TRANSMITTAL COVER SHEET

DATE: 21 June, 2024
TO: ALL PLAN HOLDERS OF RECORD
FROM: HUNTER SWATEK, AIA, PROJECT MANAGER
PROJECT: RAINBOW CITY RECREATION CENTER
GMC PROJECT NO. ABHM230021
RE: ADDENDUM NO. 3 AND
ACKNOWLEDGEMENT OF RECEIPT OF ADDENDUM NO. 3

ADDENDUM NUMBER 03

**PROJECT: RAINBOW CITY RECREATION CENTER
GM&C PROJECT NO. ABHM230021**

72J8 LOAD DIAGRAM
 SCALE: 1/8"=1'-0"

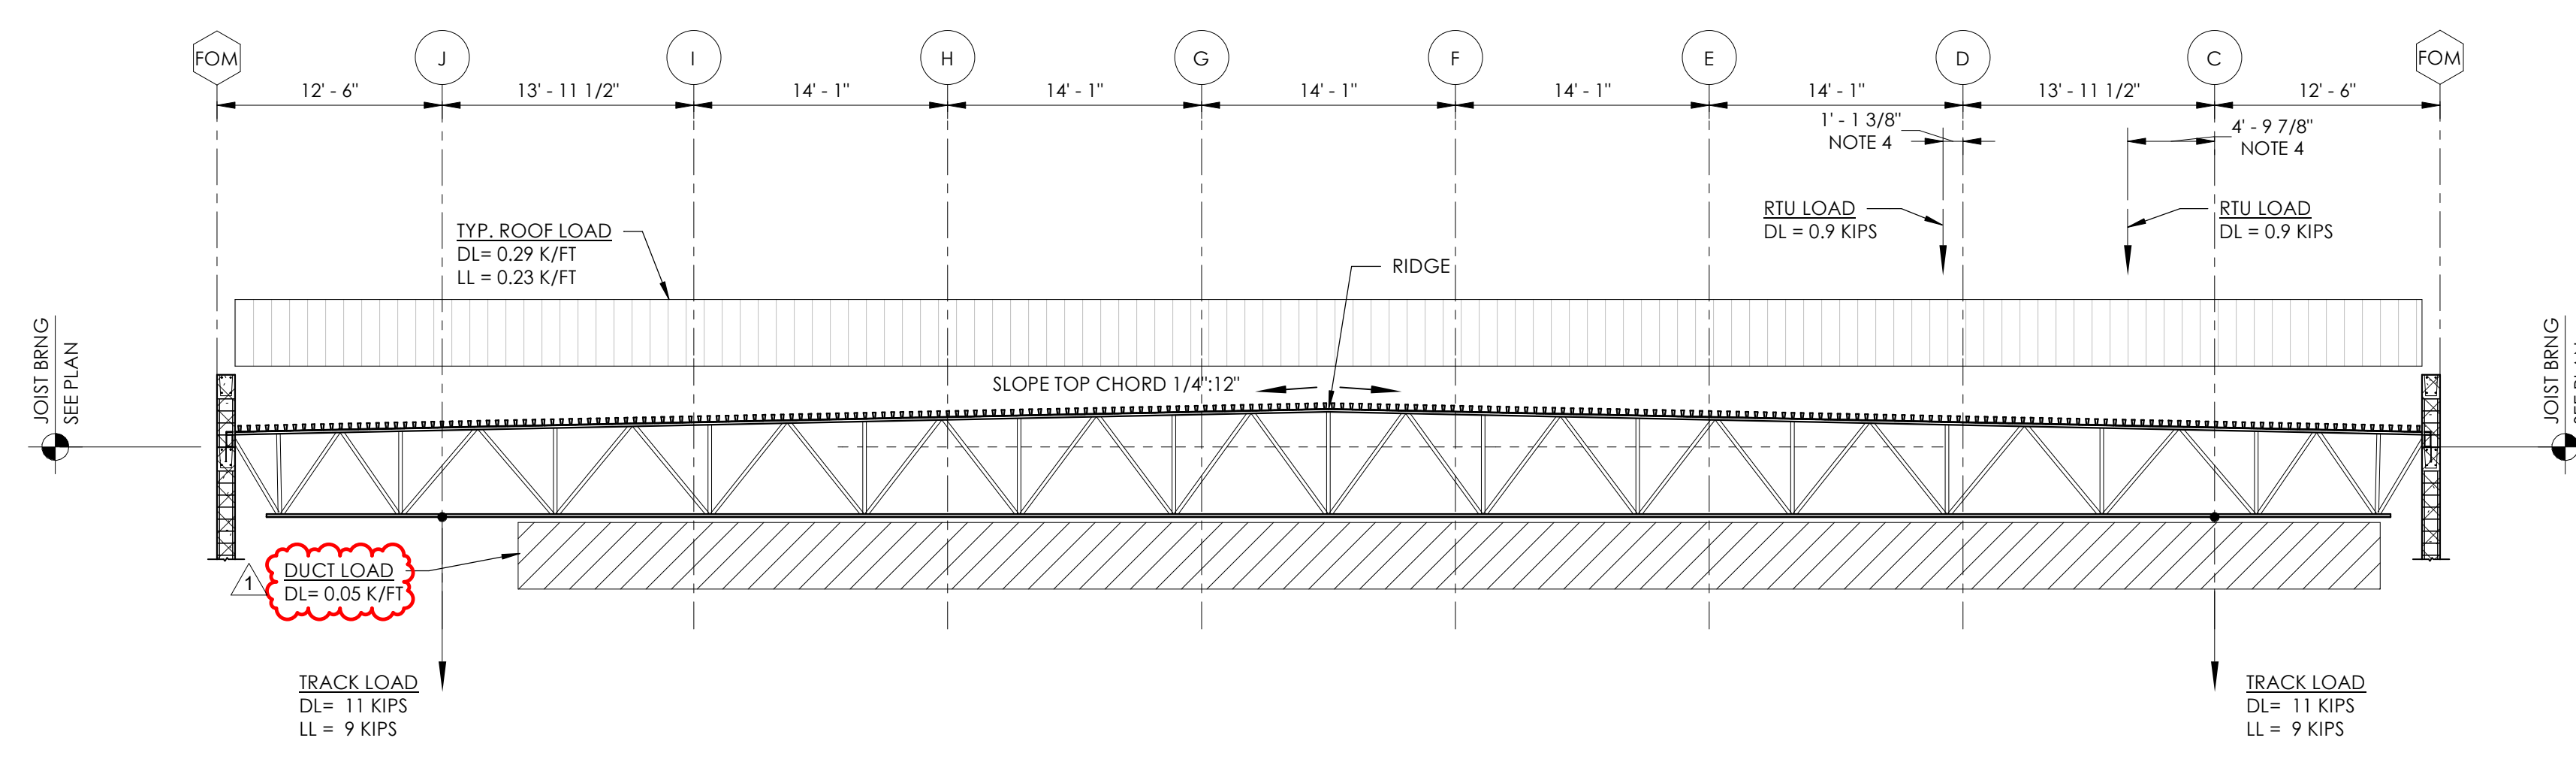
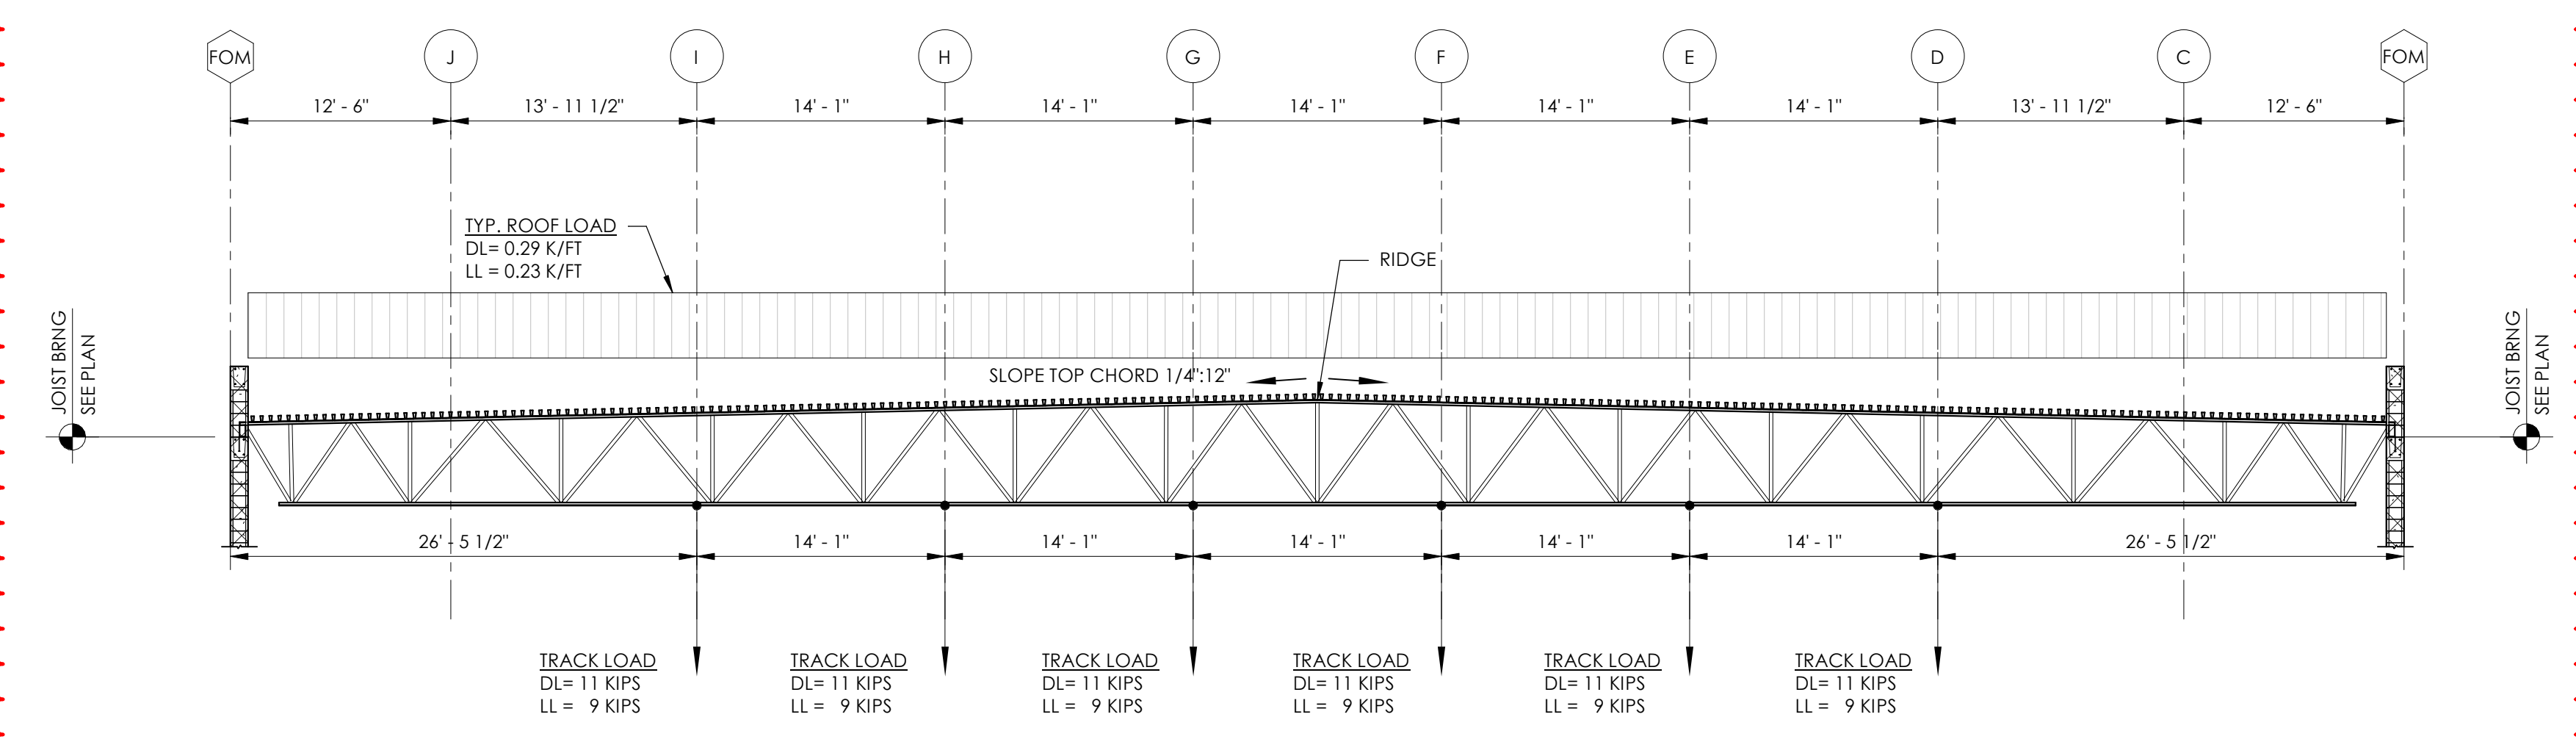
- a. ADDED Details
- R. **S1.01** – Joist Loading Diagrams
 - a. REVISED Loads
- S. **S1.08** – Joist Loading Diagrams
 - a. REVISED Loads
- T. **S2.01** – Floor and Foundation Plan

POOL BUILDING FOUNDATION AND FLOOR PLAN

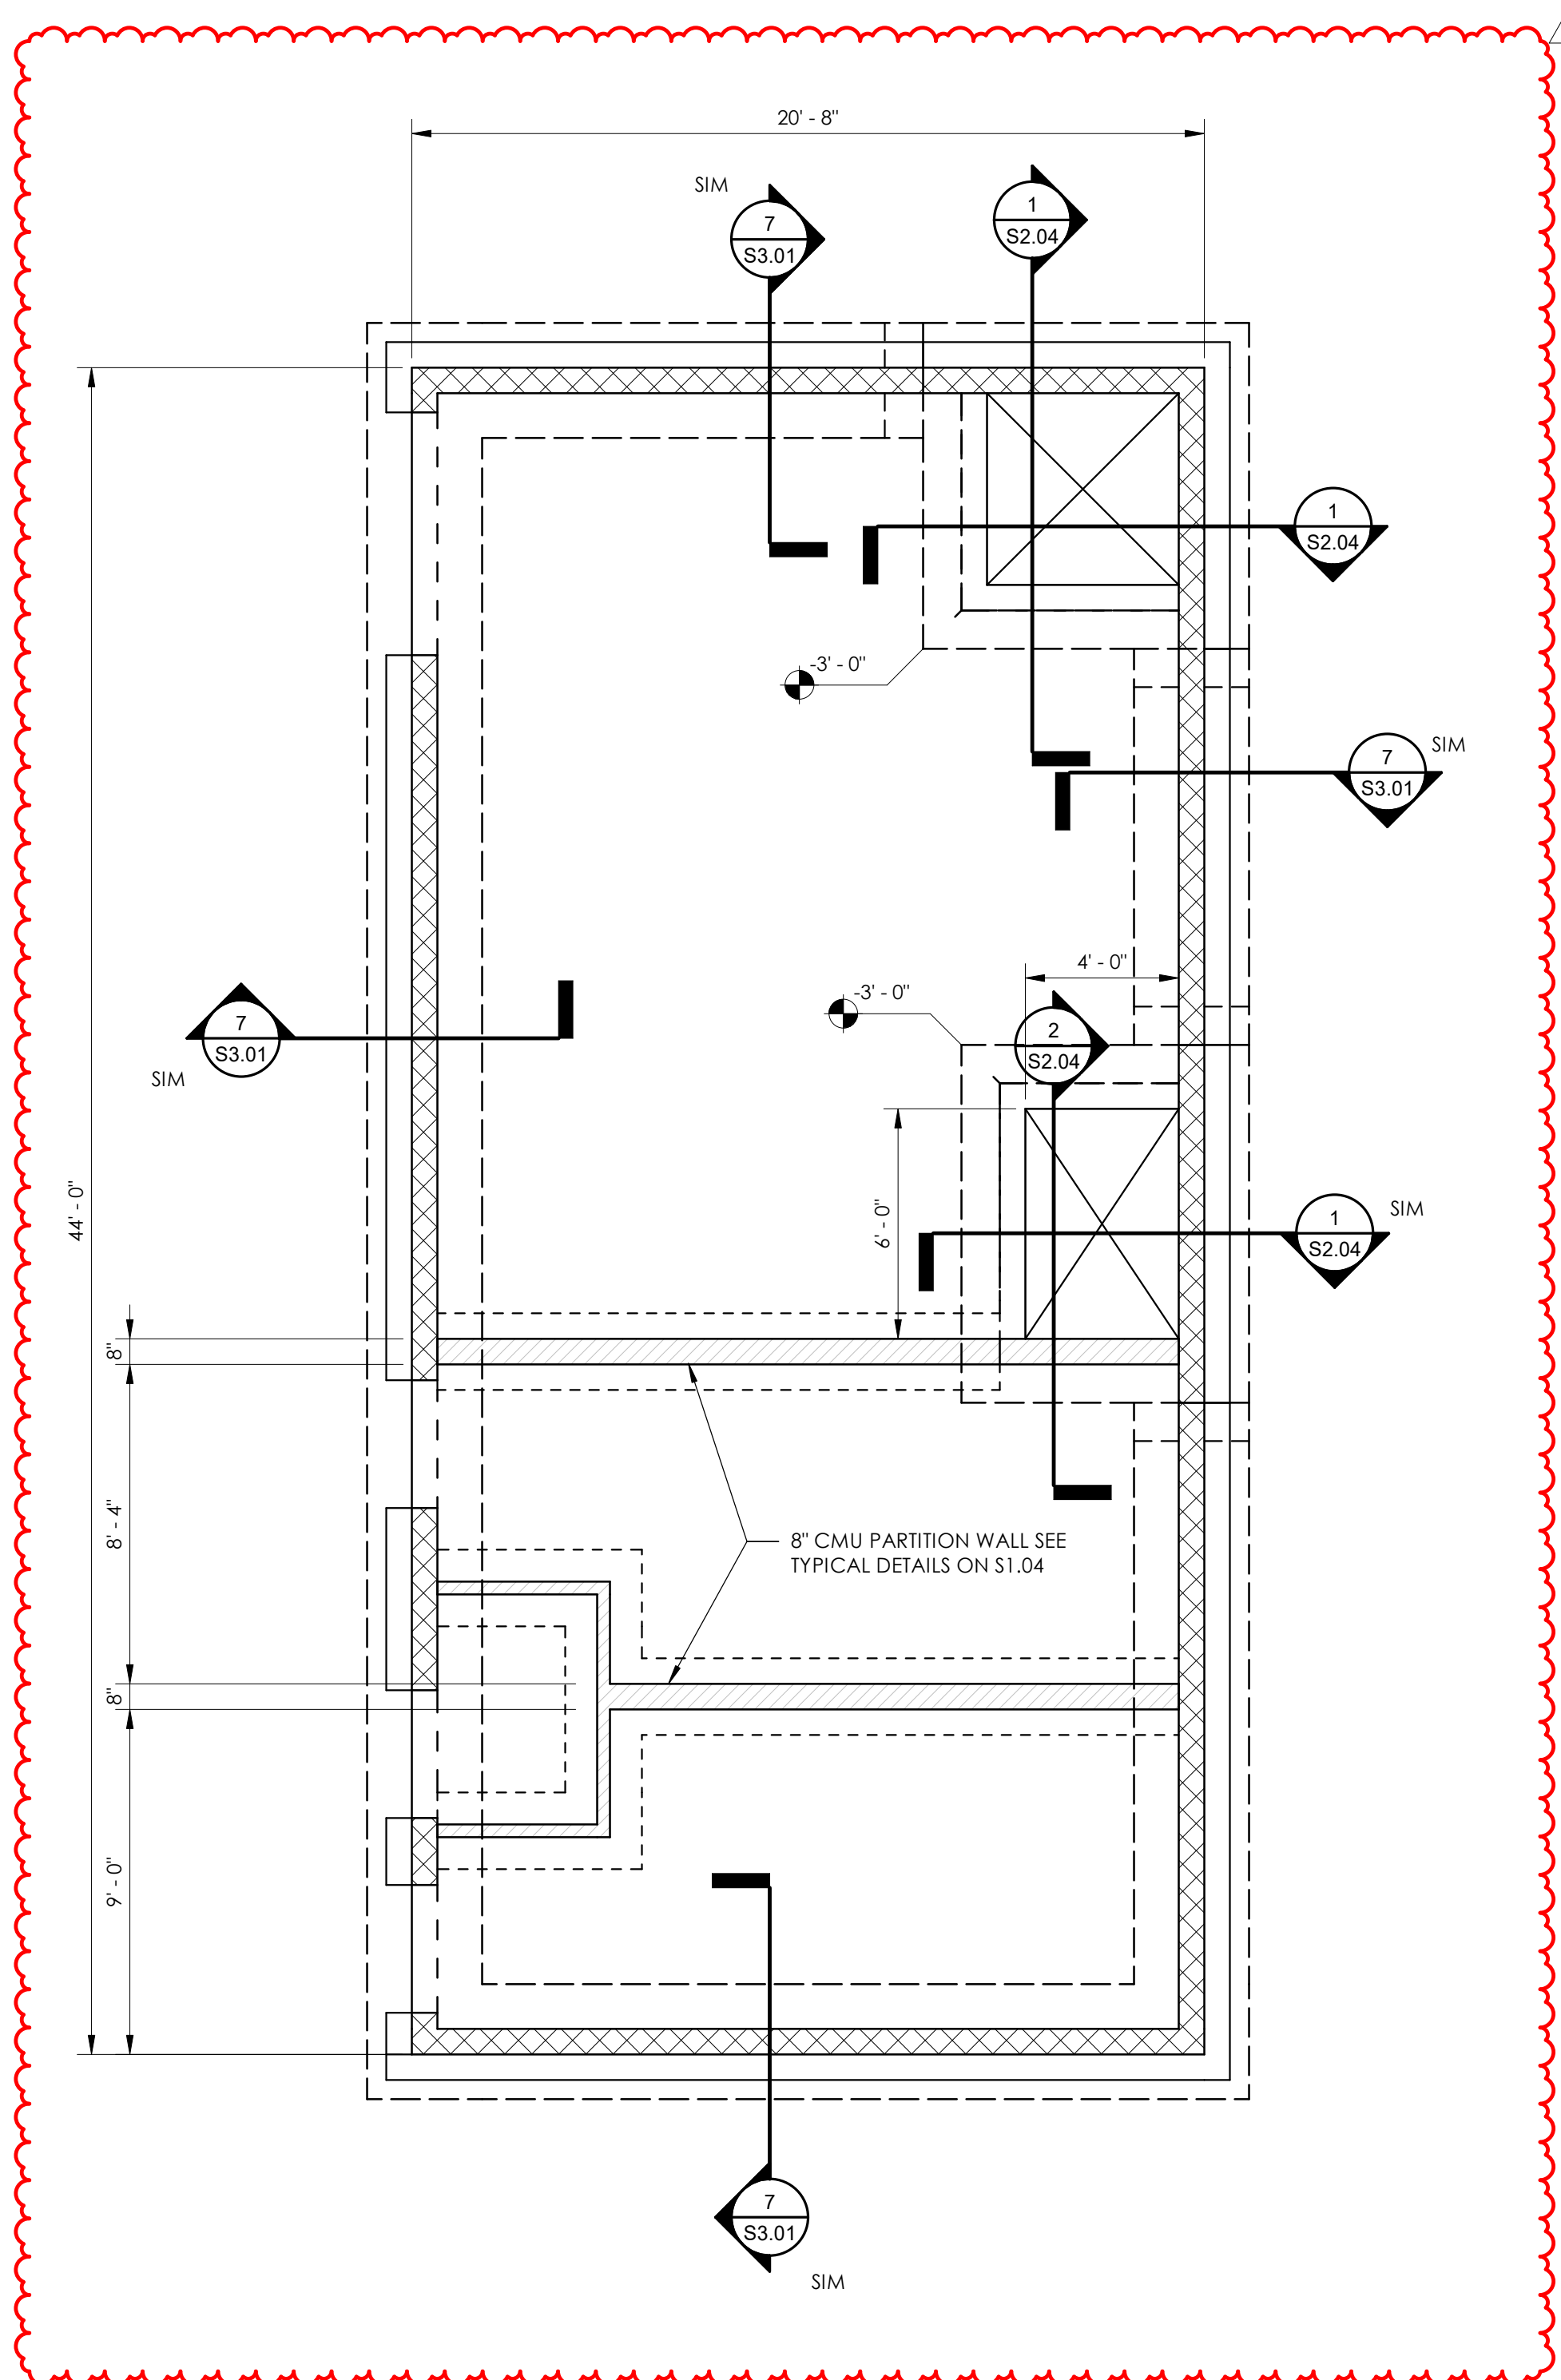
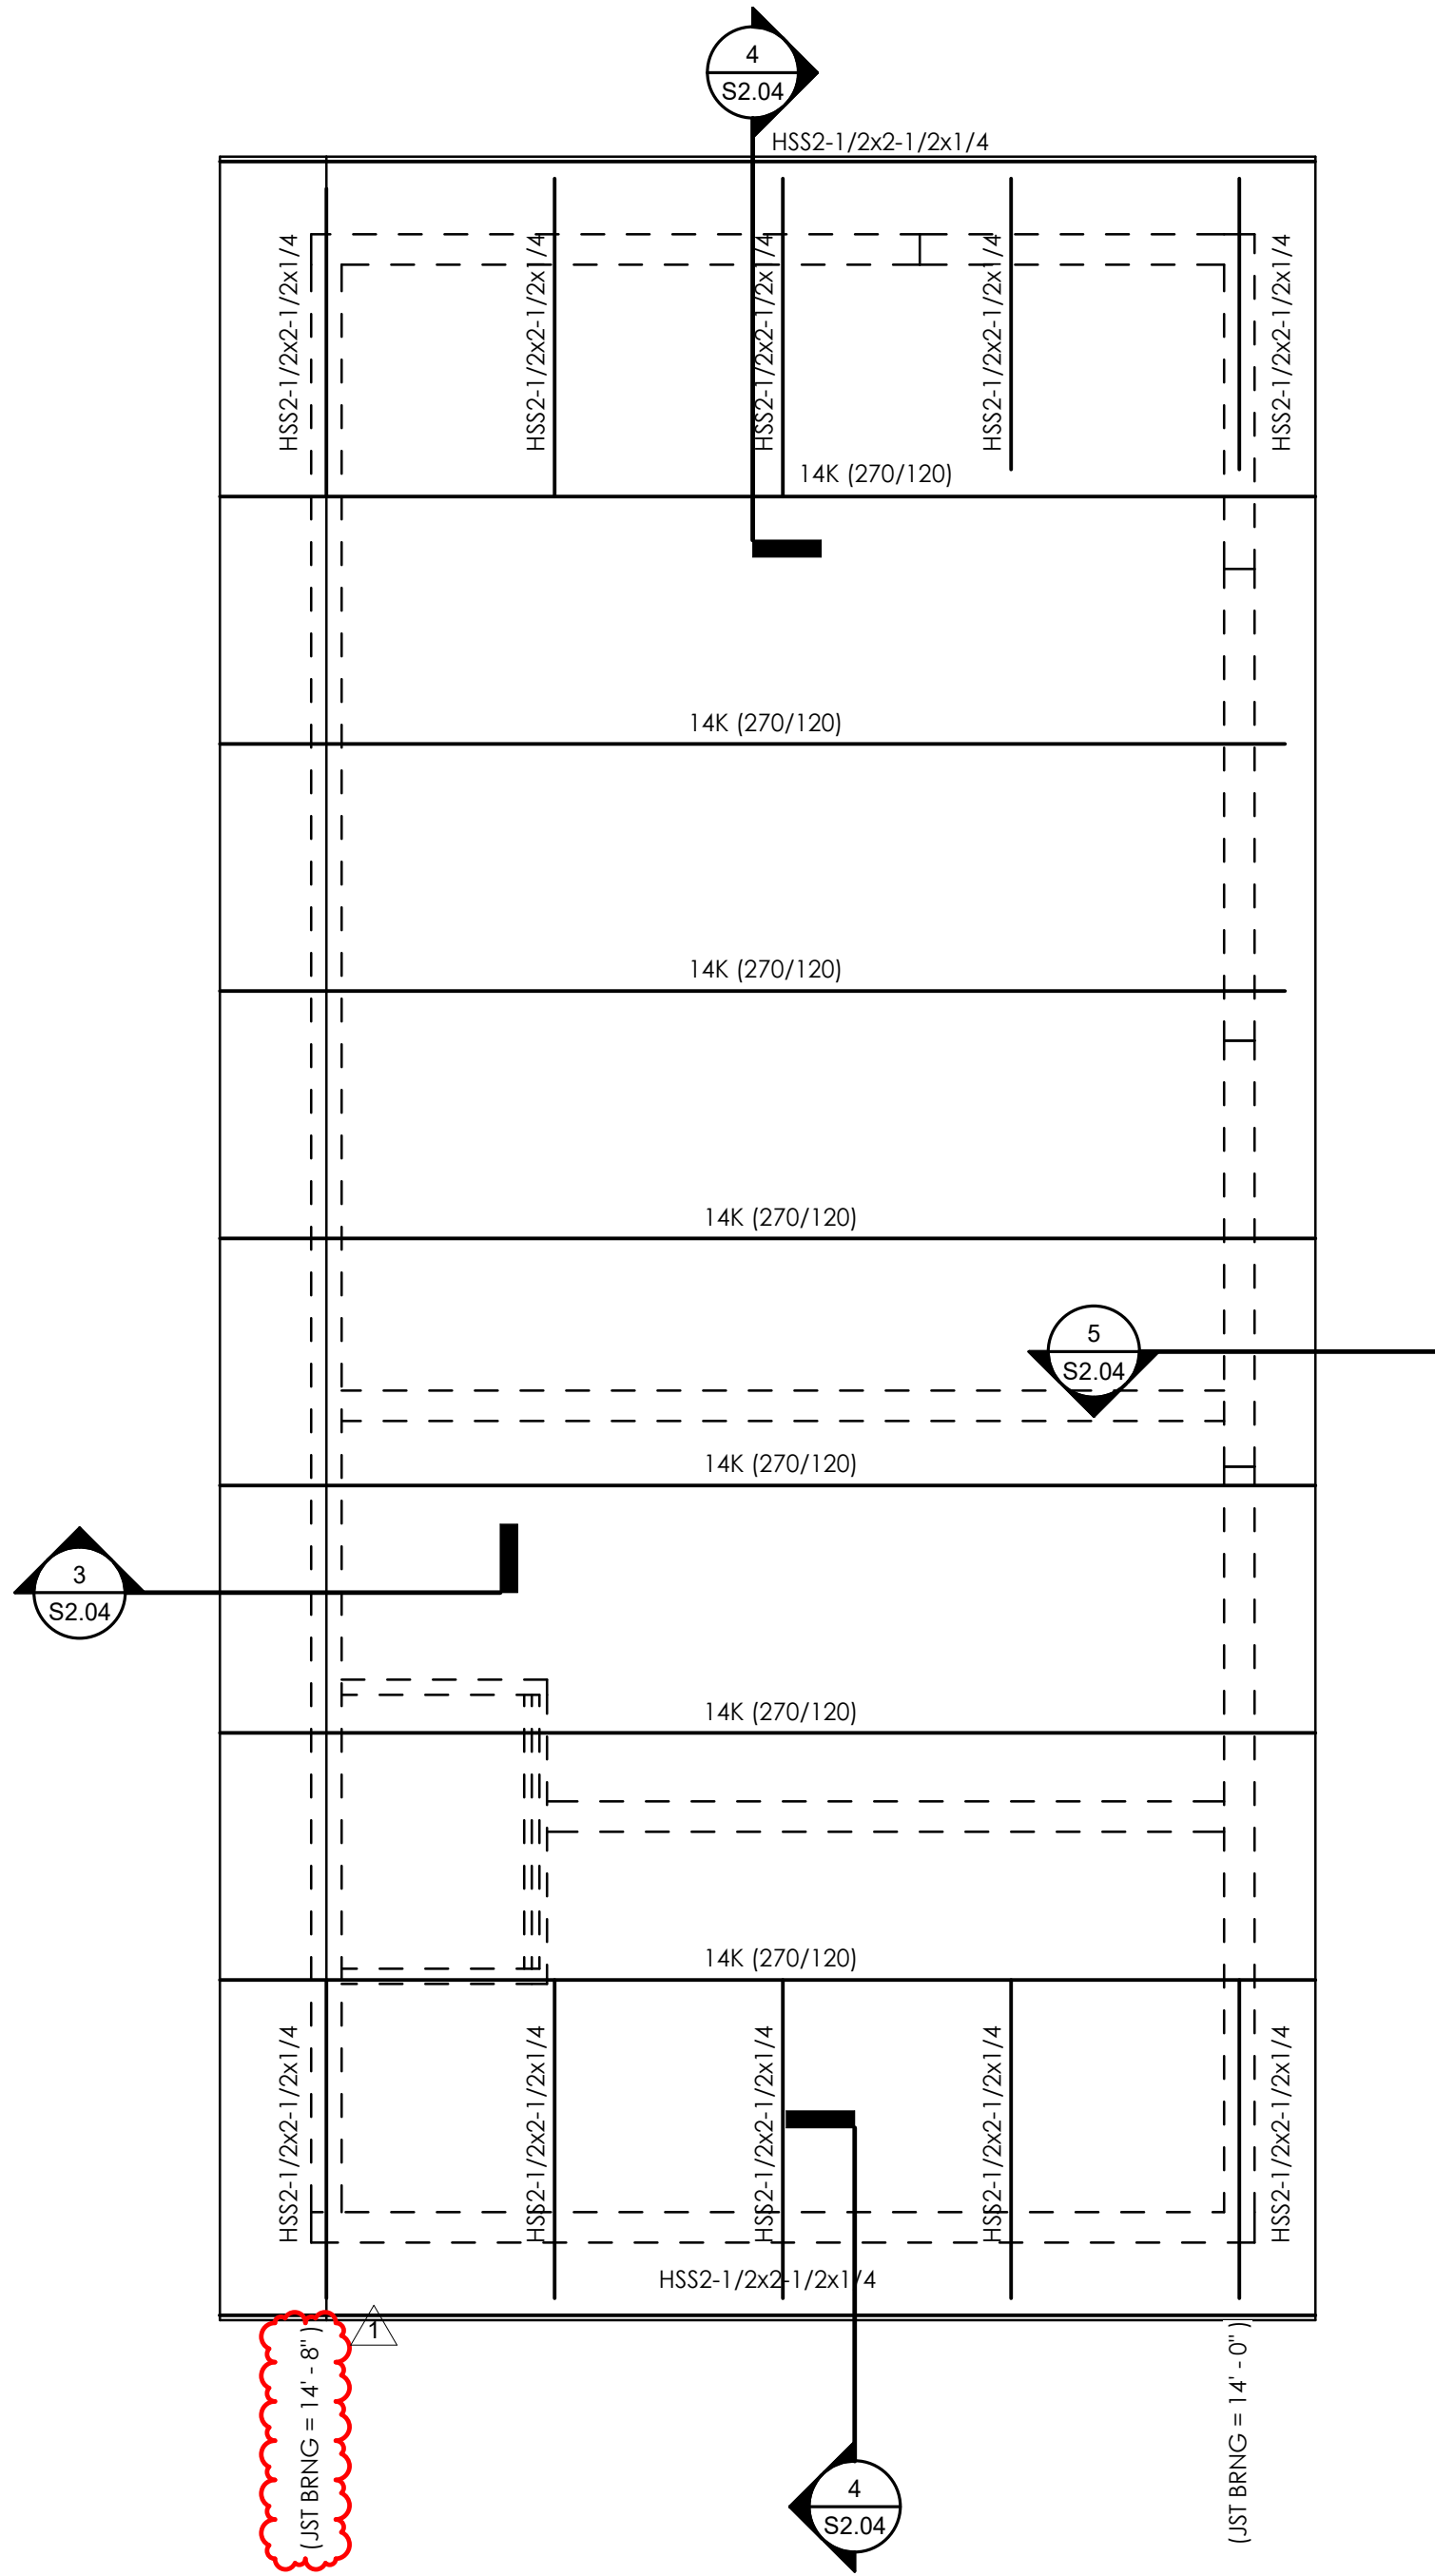
- a. ADDED Partitions and thickened slab
 - b. ADDED Section
- U. **S2.03** – High Roof Framing Plan
 - a. REVISED To match MEP
- V. **S2.04** – Pool Building Plans

- a. REVISED Partitions and thickened slab
 - b. ADDED Sump pits
- W. **S2.05** – Amphitheatre Plans
 - a. ADDED Dimensions
 - b. ADDED Section
- X. **S3.01** – Sections
